NATIONAL FIRE PROTECTION ASSOCIATION

TO: Code-Making Panel 12

SUBJECT: NEC® CMP-12 Second Draft FINAL Ballot Results (A2025)

Figure Informational Note 620.62 Selective Coordination for Overcurrent Protective Devices Supplying More Than One Elevator.

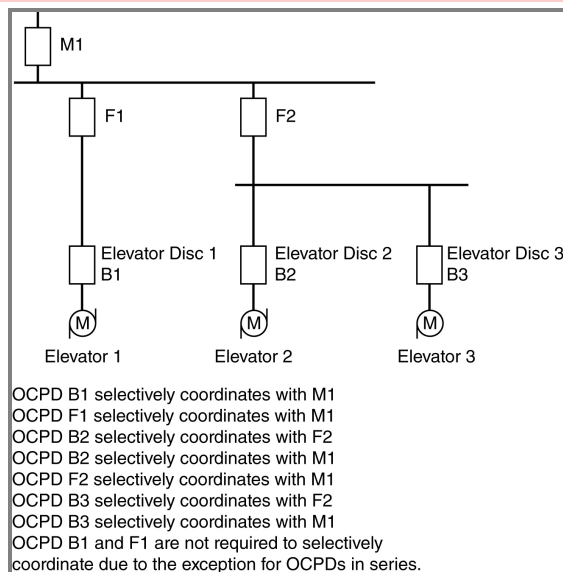
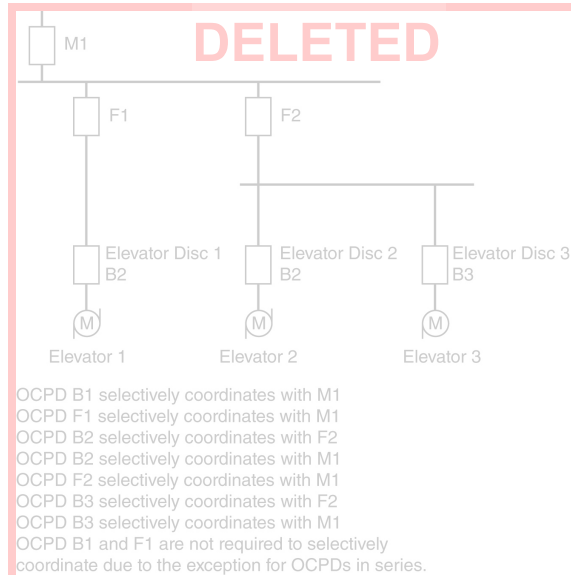
<u>File Name</u>	<u>Description</u>	<u>Approved</u>
Corrected_Figure_for_620.62_C_.docx	Figure showing where to correct the existing B2 under Elevator Disc 1 to B1 for Figure Informational Note 620.62 Selective Coordination for Overcurrent Protective Devices Supplying More Than One Elevator.

Committee Statement: The change to the overcurrent device terminology is for consistency throughout the code. The revision to the figure corrects an error in the figure as the B2 under Elevator Disc 1 in the figure should be B1.
